Docket Item #7
BAR CASE # 2017-0086

ISSUE: Re-Approval of Previously Approved Permit to Demolish/Capsulate

LOCATION: 209 Gibbon Street

BAR2017-00086

Figure 1: Areas to be Demolished/Capsulated

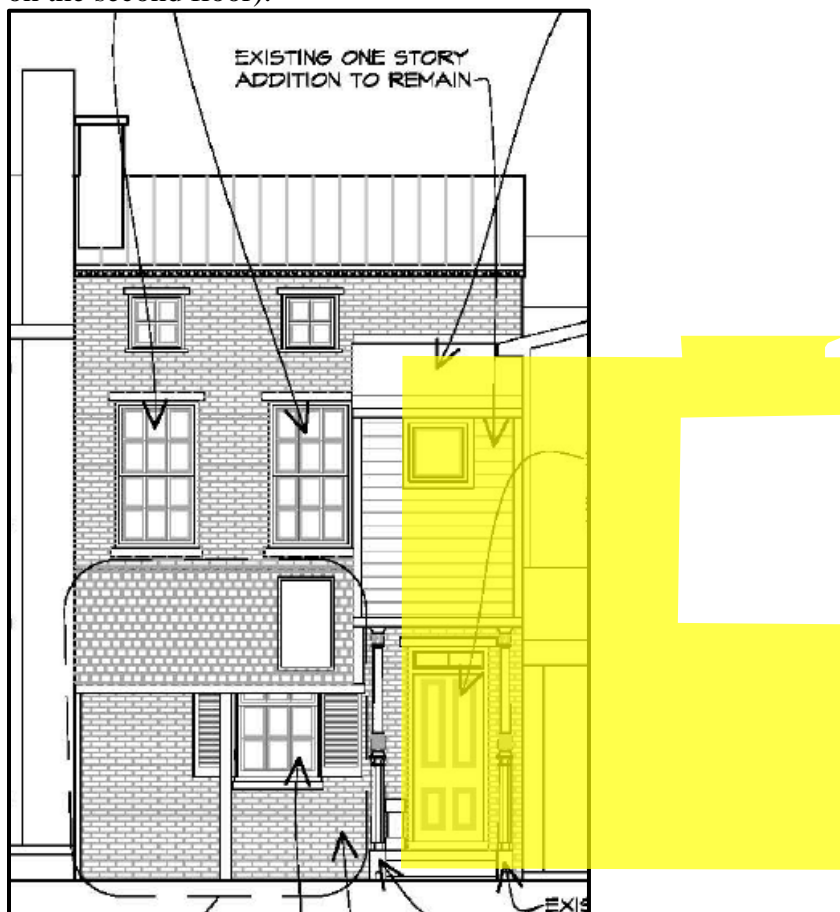
The re-approved Permit to Demolish/Capsulate is requested as part of the proposed new construction of a two-story rear addition (117 square feet) at the rear of the property where, currently, a covered patio and a small second-story, one-room addition exist. The existing, one-story covered patio (which covers 256 square feet) will be enclosed; the existing second-story addition will remain in situ although the roof structure will be changed to align with the new addition; and the first and second stories of the main block's northern elevation will be capsulated while portions will be demolished (the two existing six-over-six double-hung windows on the second floor will be removed and reused in the new addition). [Figure 1] Approximately 68 square feet of exterior wall (8.5 feet by 8 feet) on the second floor will be demolished to create a passage to the new addition. Approximately 280 square feet of exterior wall will be capsulated by the new addition (181 square feet on the first floor and 99 square feet on the second floor).

While the scope of the proposed demolition/capsulation affects historic (mid-19th-century) material, the amount is modest and affects fabric which is not of unusual or uncommon design, texture, or material. BAR staff finds that none of the criteria for demolition/capsulation are met and the Permit to Demolish/Capsulate should be granted.

Staff recommends re-approval of the Permit to Demolish/Capsulate with the following condition:

1. The applicant shall be required to photographically document the condition of the existing alley prior to initiating any construction and shall be responsible for the mitigation of any damage caused by construction of this project.
